Project No. 16-033A

Subject: Addendum No. 3 for Construction of Oil Dock 15

Subject: Addendum No. 4 for Construction of Oil Dock 15

UTILITIES SITE PLAN

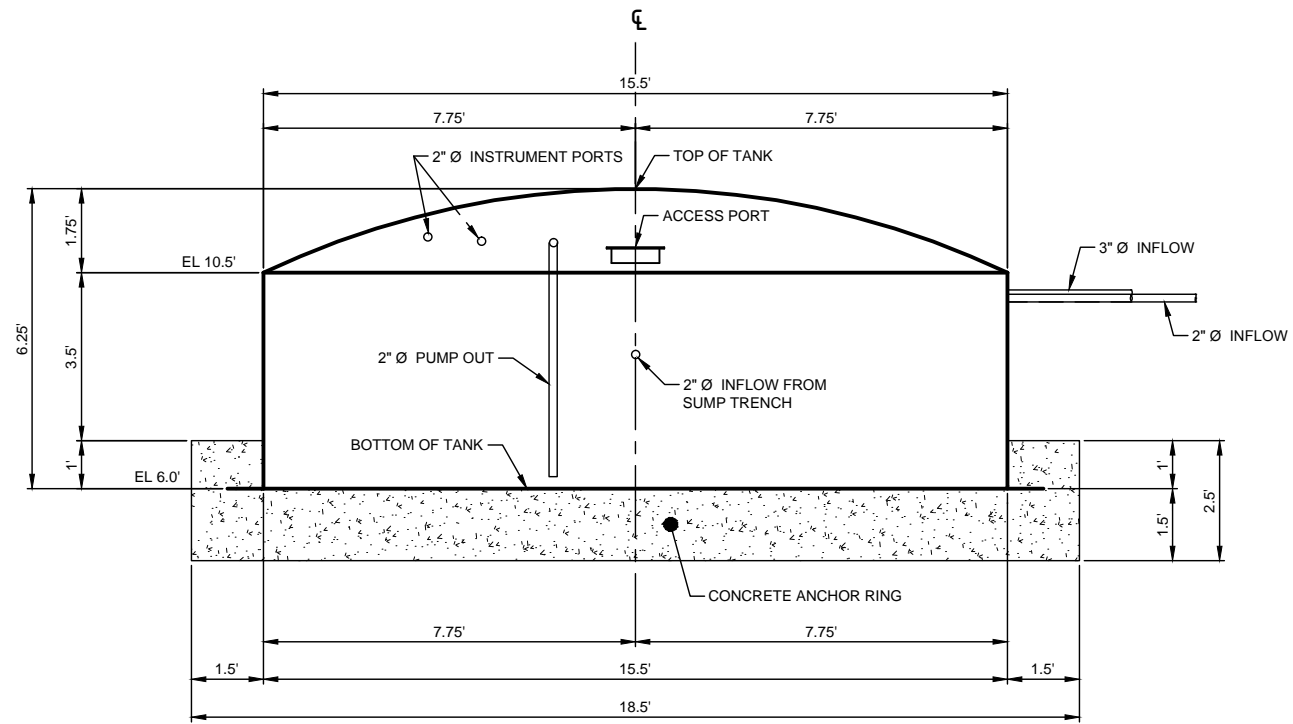
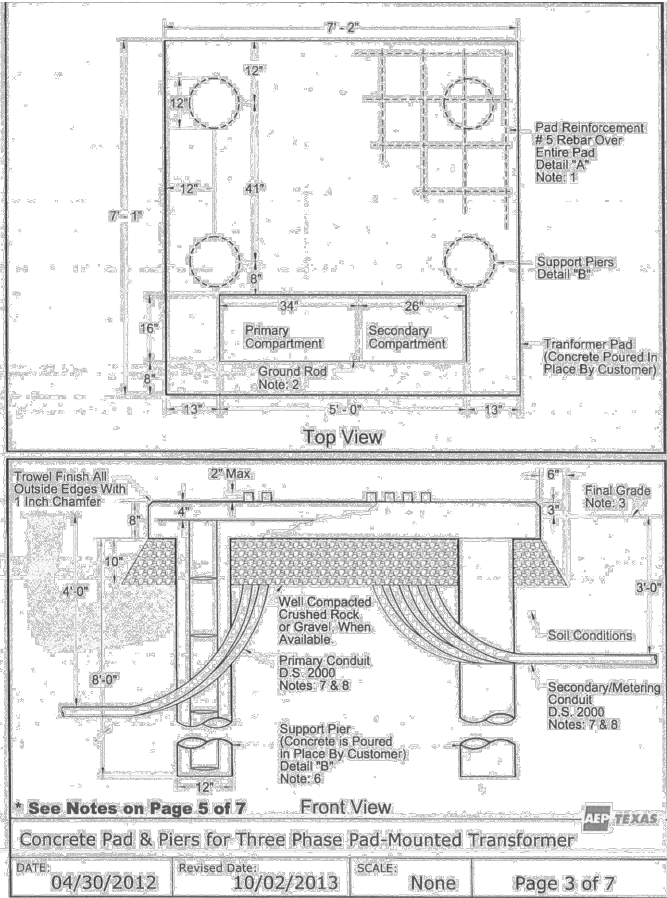
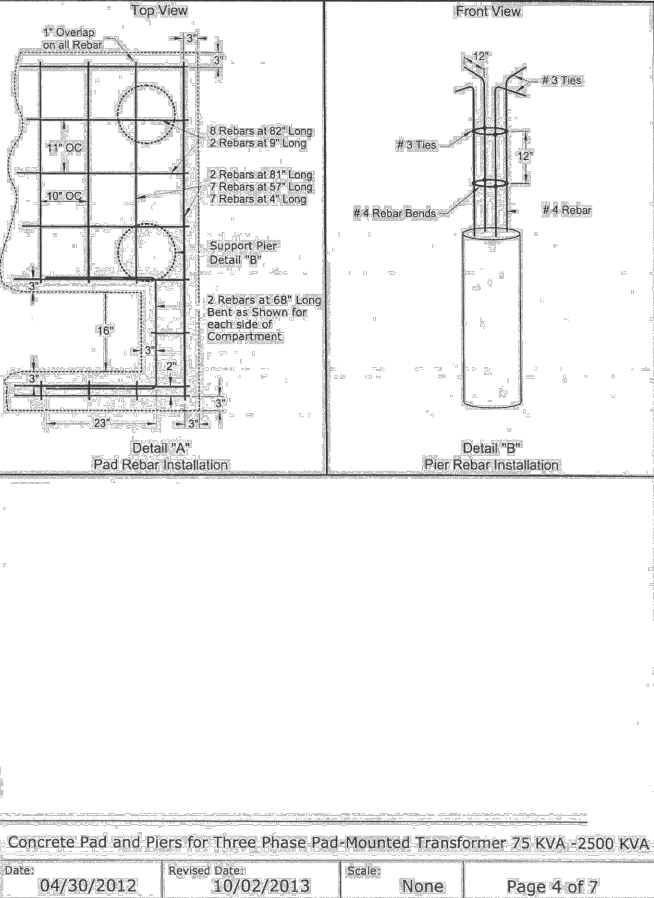
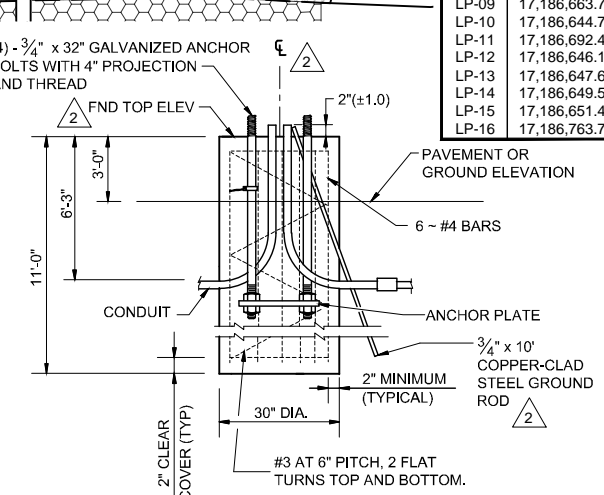
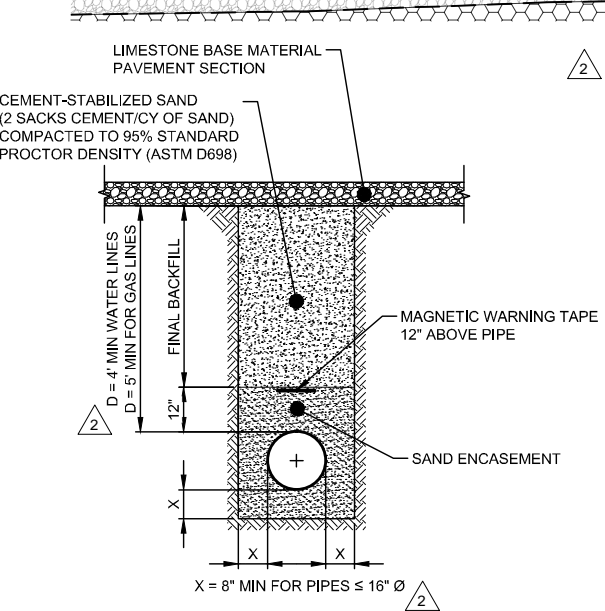
Drawing No. 06A - Utilities Site Plan – Show location of light poles with location coordinates. Show firewater monitors. Revised details of utility trench. Added callouts for sump tank, electrical building, transformer foundation, and service pole for power supply.

UTILITIES DETAILS

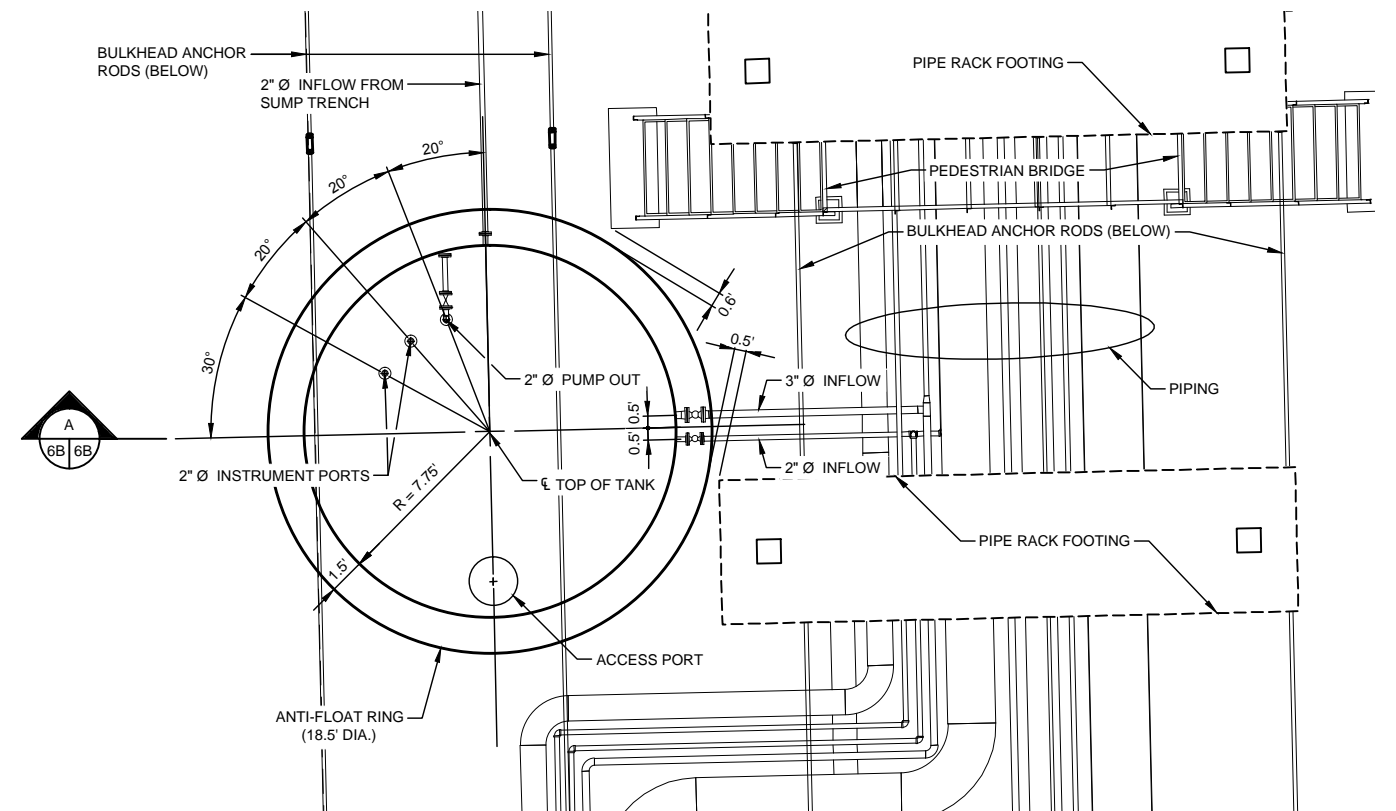
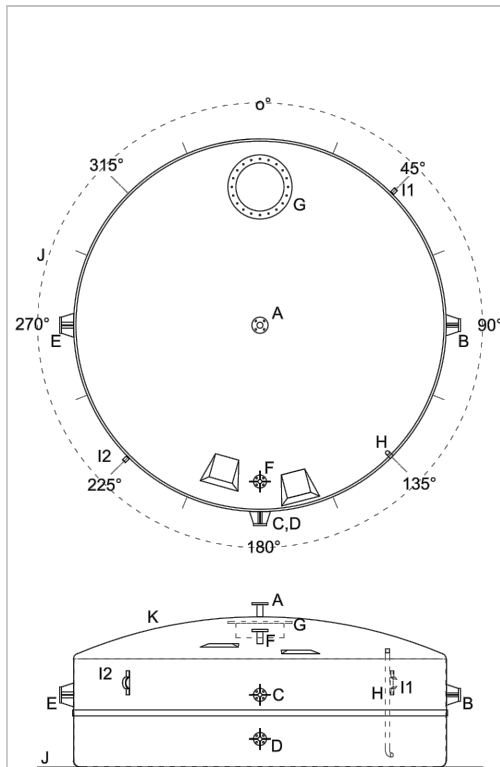
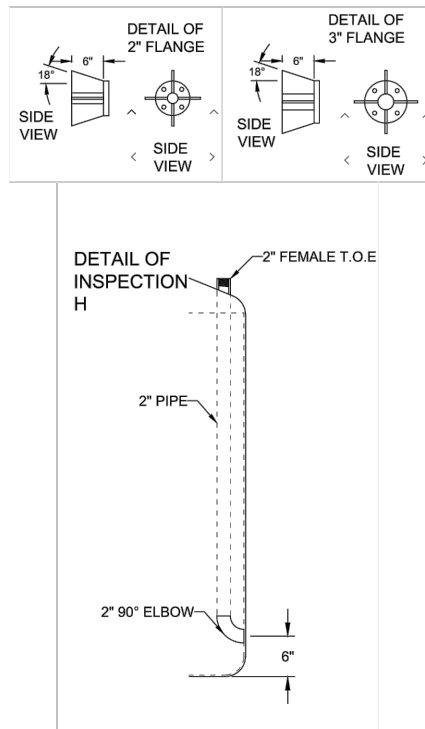
Drawing No. 06B – Utilities Details

SITE CROSS SECTIONS

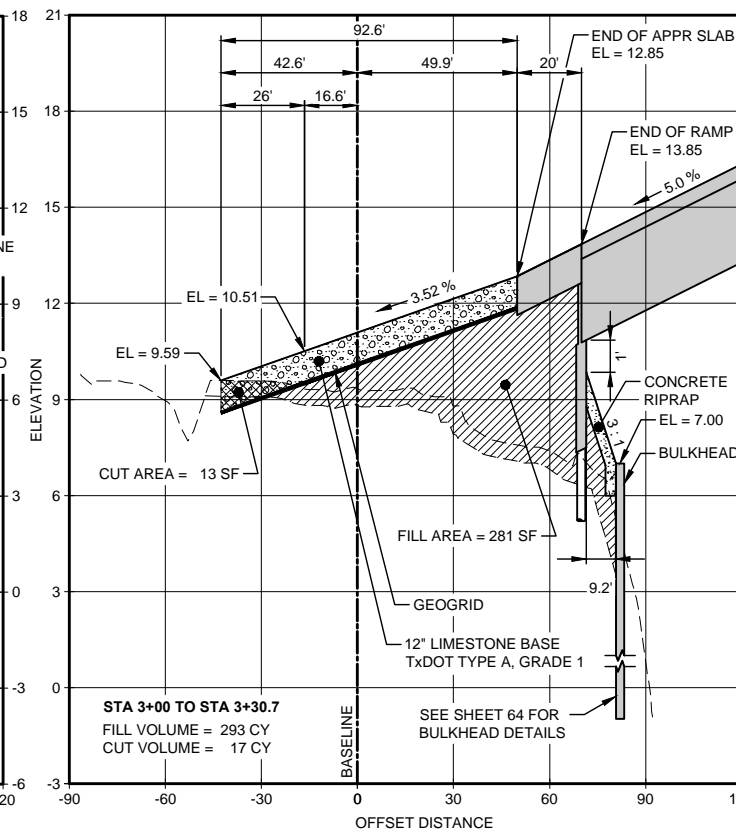
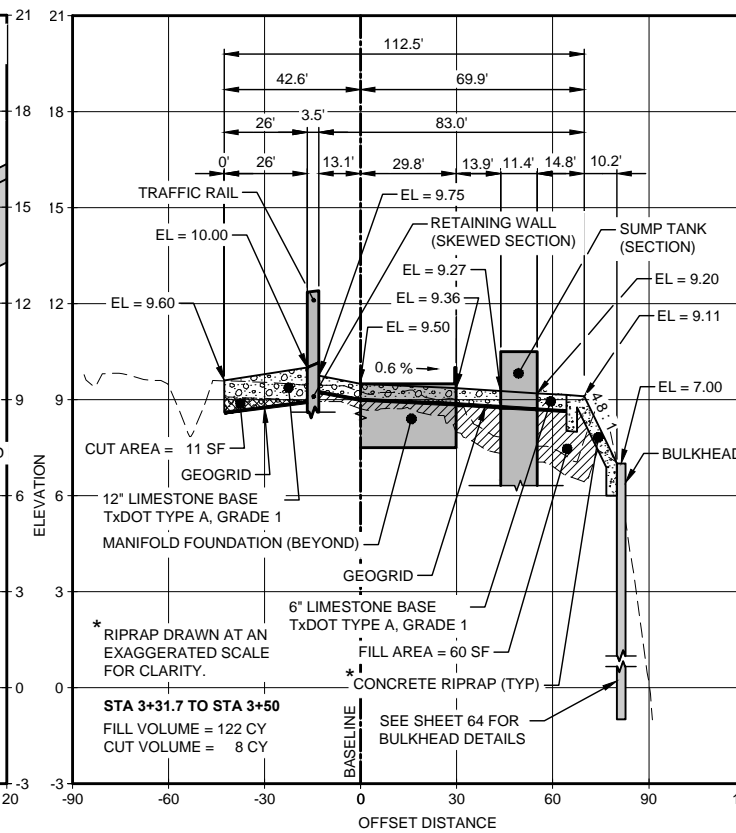
Drawing No. 12. – Site Cross Sections – Revised sections for Station 3+30.7 and Station 3+50 to reflect civil site plan revisions.

TYPICAL PIPELINE CROSSING DETAILS
SCALE: N.T.S.

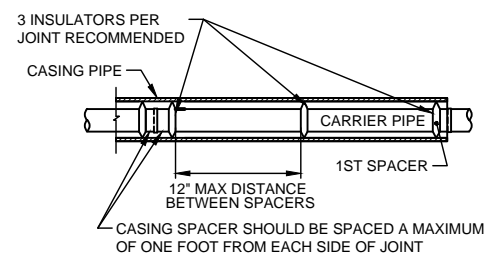
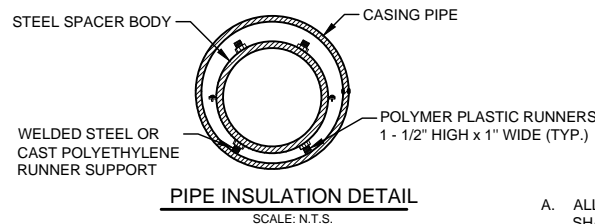
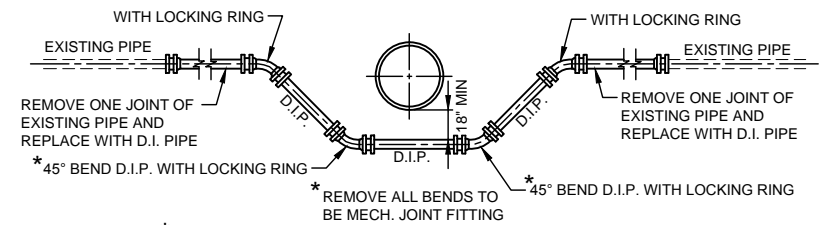
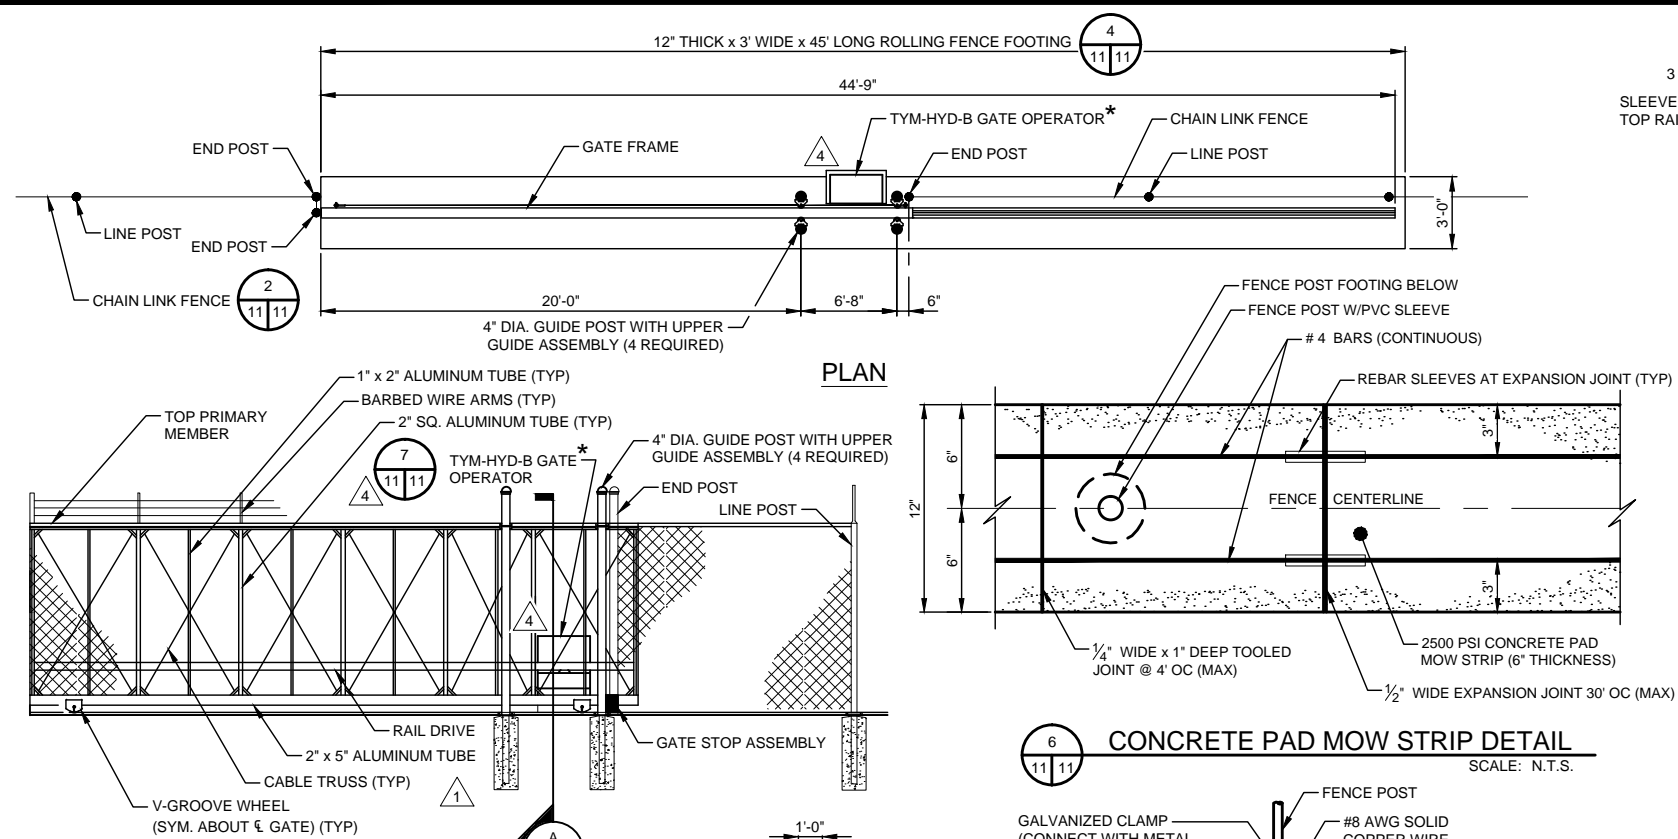
Drawing No. 06B - Utilities Details – Added Detail No. 2 "Typical Pipeline Crossing Details" illustrating pipe casing requirements.

SITE DETAILS

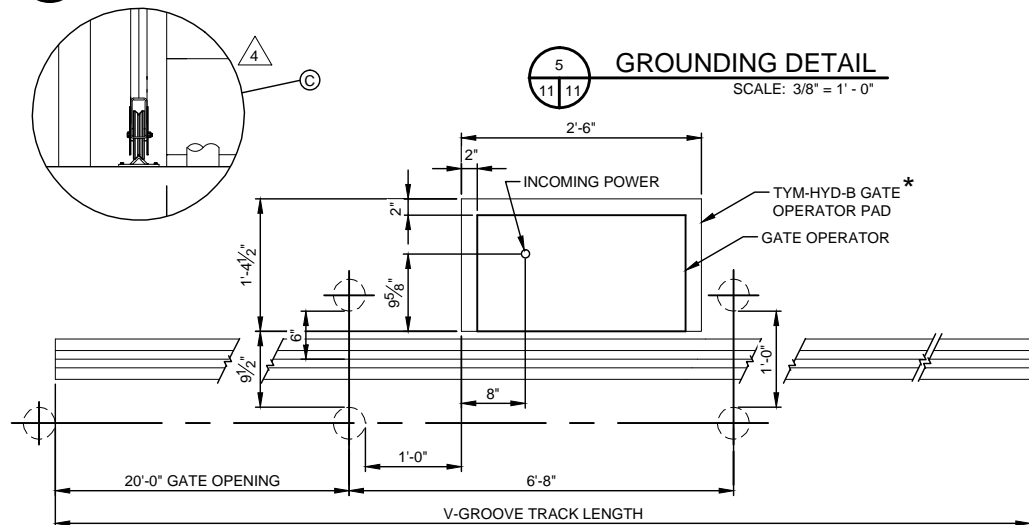
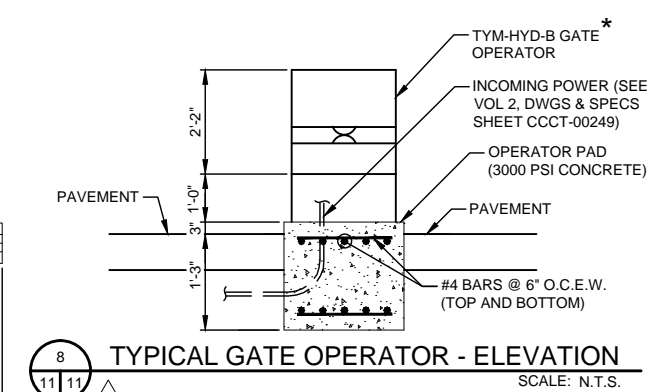
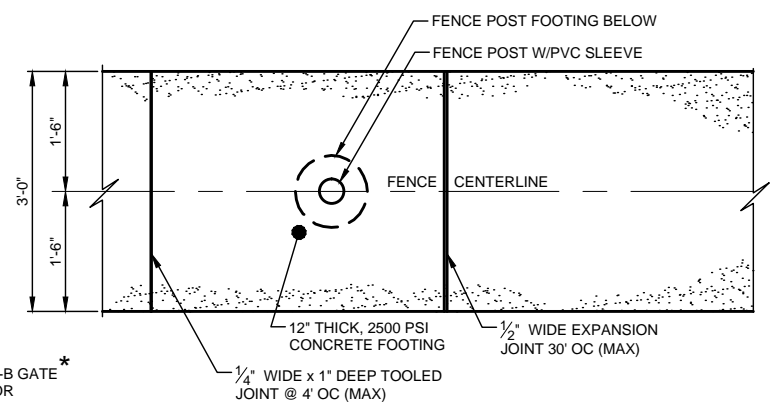
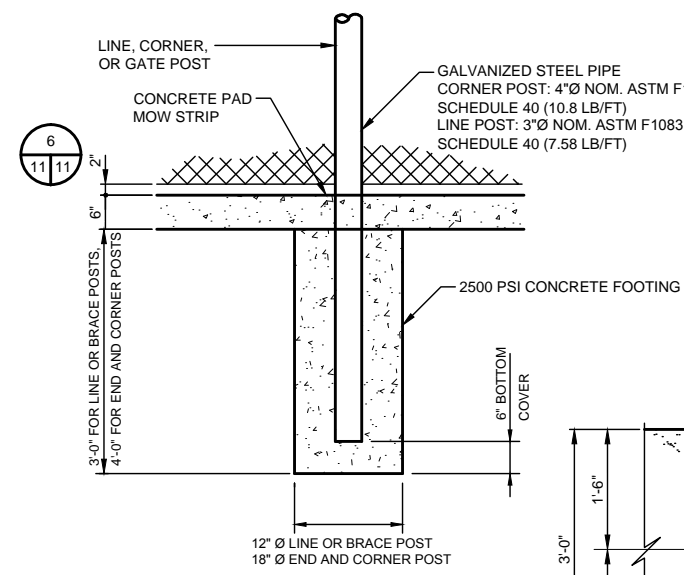
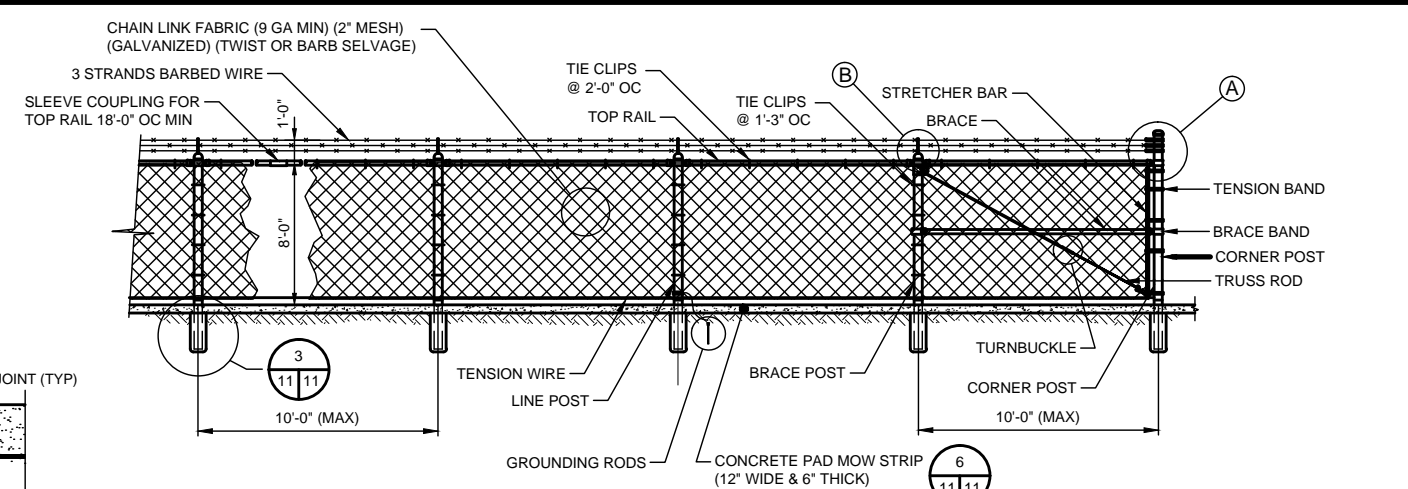
Drawing No. 011 - Site Details - Added Callouts for TYM-HYD-B Gate Operator to Detail 1 "Sliding Gate Detail". Added new Detail No. 7 "Typical Gate Operator - Plan". Added new Detail No. 8 "Typical Gate Operator - Elevation" as well as new Section A "Section at Operator".
